W41, W55 & W56 WIREFEEDERS

CHATTERING CONTACTOR IN POWER SOURCE

Fig 1

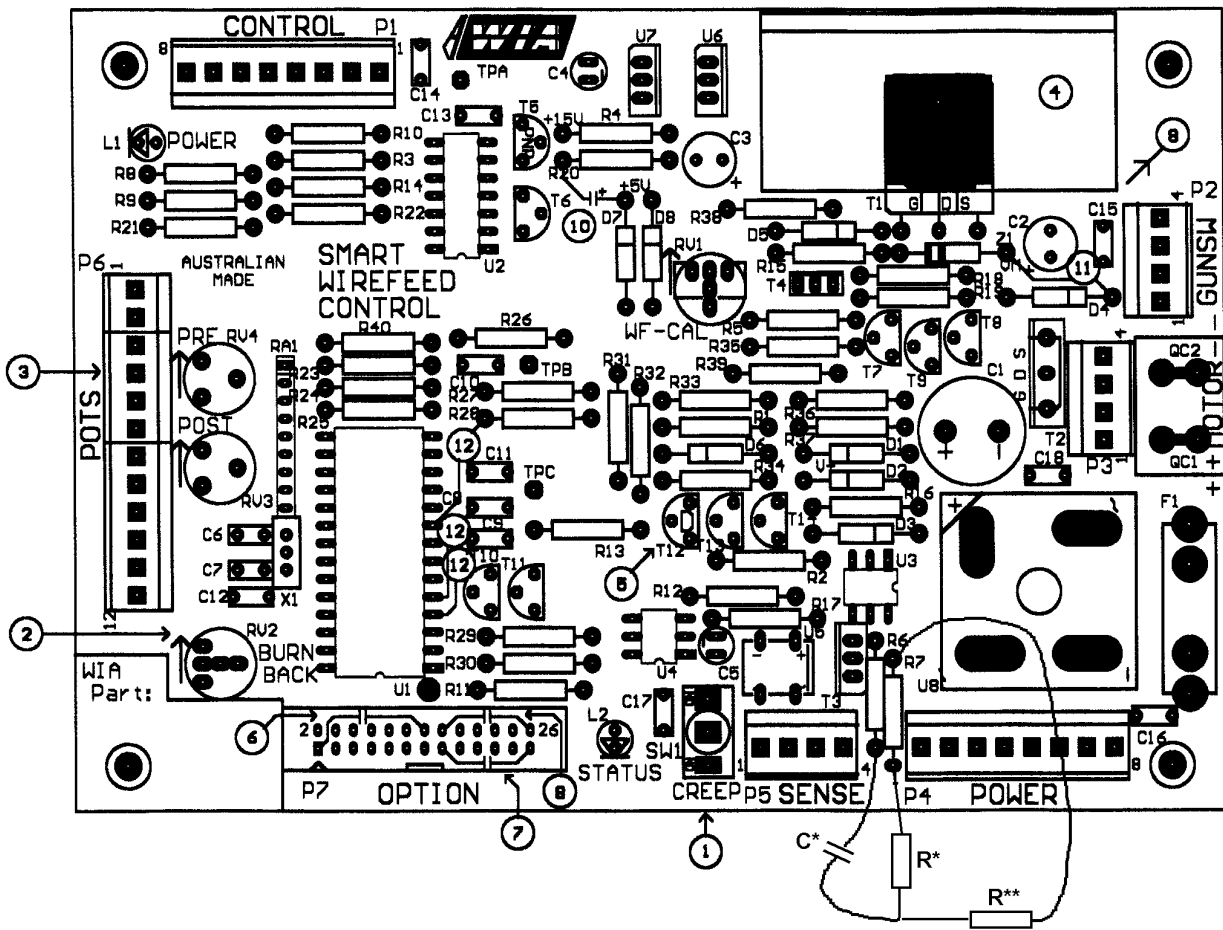
We have become aware that the contactor in a Weldmatic power source connected to a W41-0, W41-1, W55 or W56 may chatter intermittently. This can occur in either of two instances.

1. When a TIG (or plasma) machine using HF is used nearby.
2. When the MIG gun trigger is released.

The cure in either case is to fit a snubber assembly to the triac circuit which turns the contactor on. This modification is suitable for any issue of W41-11 or W41-10 pcb.

Remove R7 (see Fig 1 on Pg 2)

Add C*, R* & R**

C* = 0.1uF, polyester

R* = 390ohm, ¼ watt

R** = 47ohm, ¼ watt
